944-SPEC - 944SPEC - low cost wheel to wheel racing

Body (6-10) Posted by joepaluch - 07 Nov 2009 22:57

These are PROPOSED changes gather from the various discussions. Use this area to further discuss these. Based on the feedback we get the rules will be changed (or not) to reflect these updates. It is anticipated that some rules changes will NOT be accepted, but all are up for debate.

9 Lexan Windshield

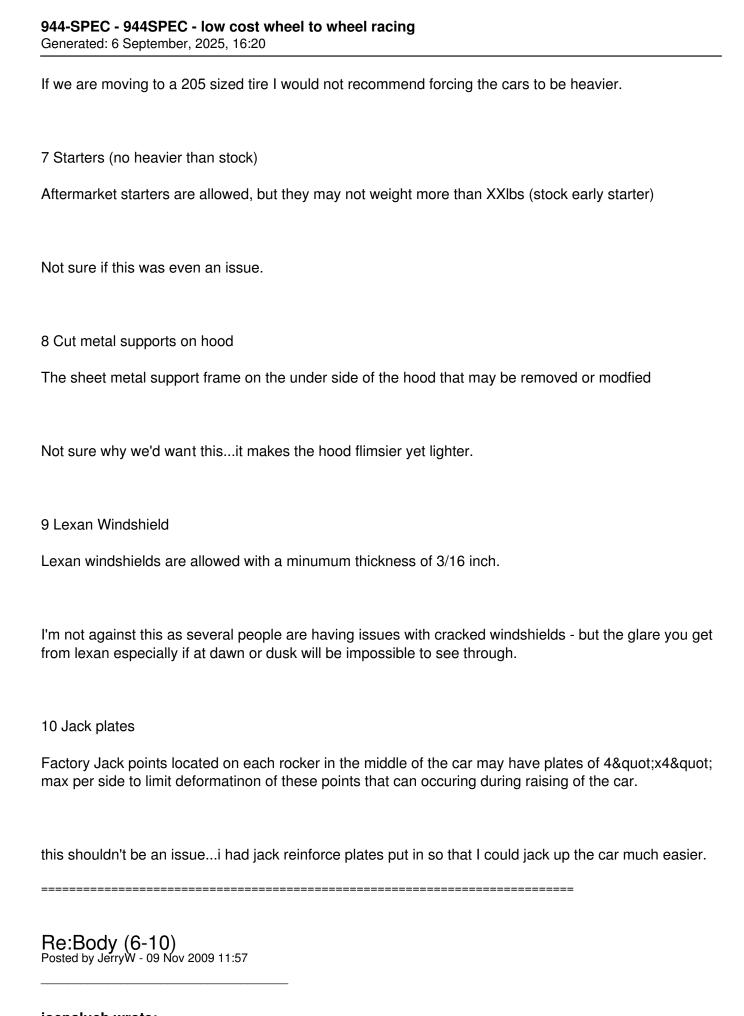
Lexan windshields are allowed with a minumum thickness of 1/4 inch. (EDITED 11/24/09, Was 3/16)

- 6: No haven't heard good arguments to change.
- 7: No stock starters are plentiful and I don't hear of frequent failures.
- 8: Neutral.
- 9: No upkeep of Lexan would be more intensive and I believe Lexan would need to be replaced more often that the stock glass for safety.
- 10: Yes safety for jacking.
